AMENDMENT OF SOLICITATION/MODIFICATION OF CONTRACT

8. NAME AND ADDRESS OF CONTRACTOR (No., Street, County, State and Zip Code)			
		X	9A. AMENDMENT OF SOLICITATION NO. W917PM-09-R-0034
		X	9B. DATED (SEE ITEM 11) 12-Dec-2008
			10A. MOD. OF CONTRACT/ORDER NO.
			10B. DATED (SEE ITEM 13)
CODE	FACILITY CODE

The purpose of this amendment is to provide revised Appendix A, incorporate Appendix H and provide additional vendor questions and Government responses.

Appendix A

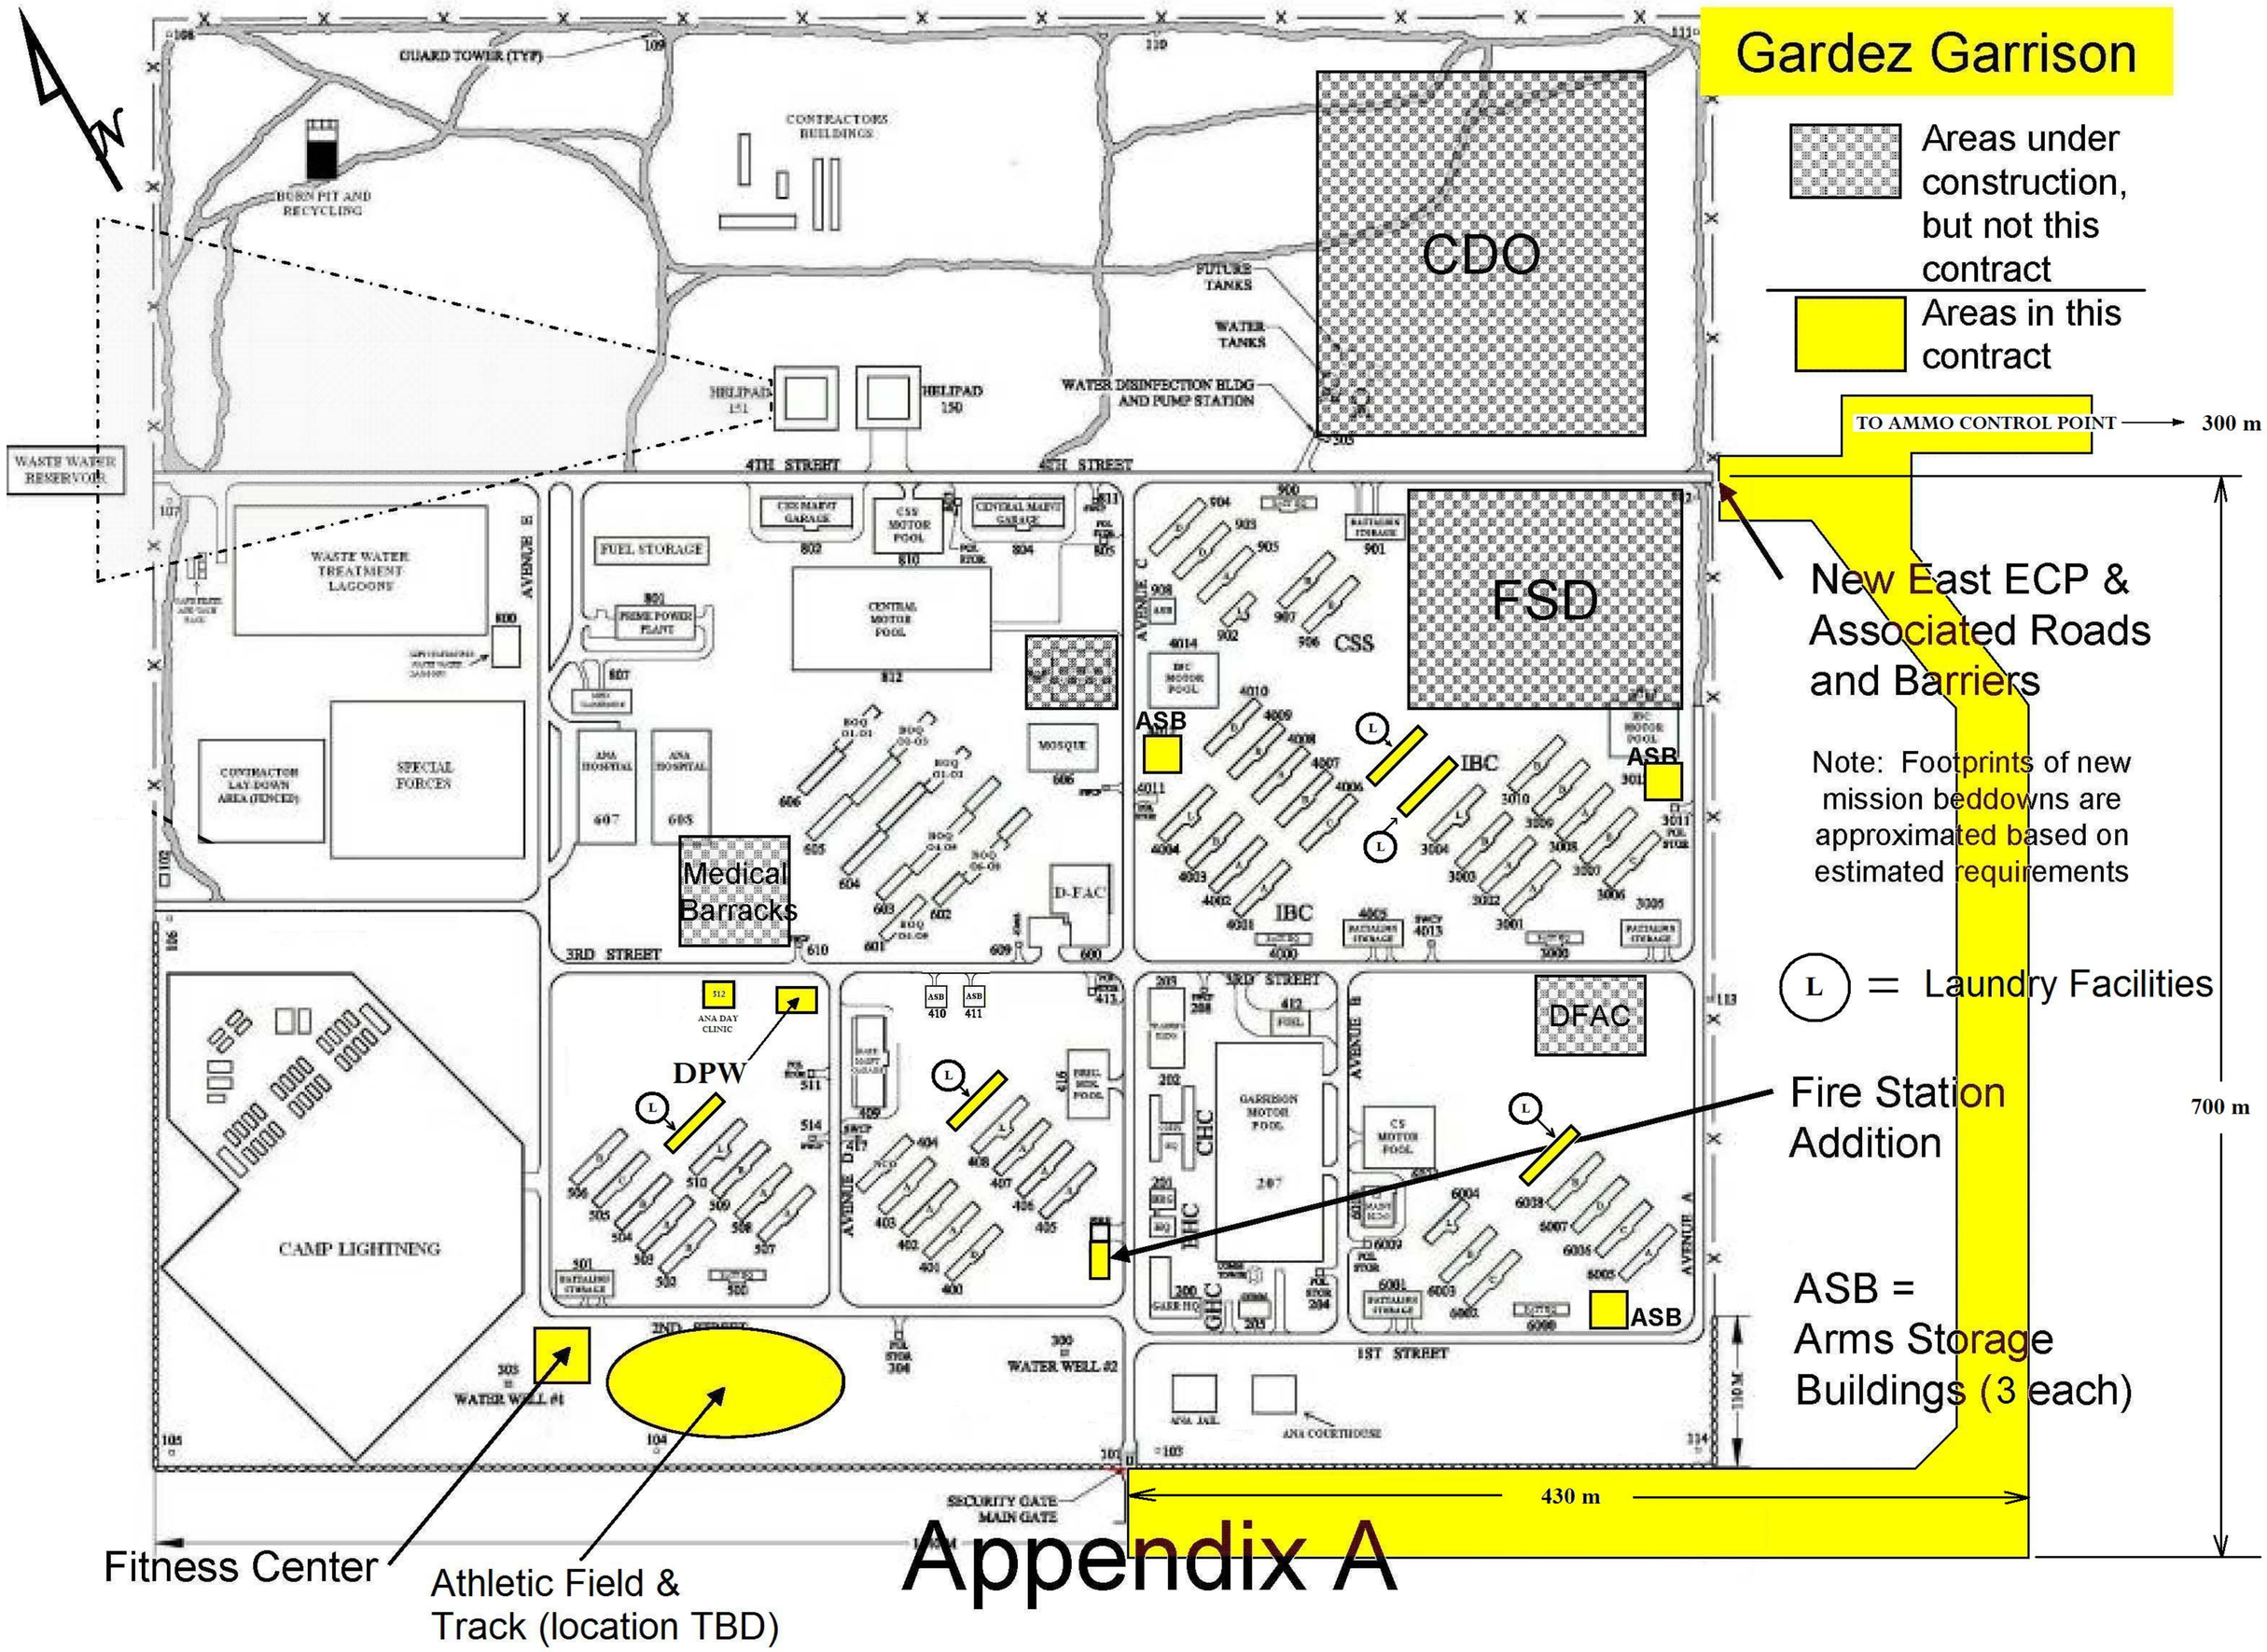
a. This amendment incorporates revised Appendix A drawing of Gardez Garrison.
b. This amendment adds Appendix H, which provides current Electrical Equipment Data for Gardez.
c. This amendment adds additional vendor questions and Government responses.
d. The due date for proposals remains 14 January 2009.
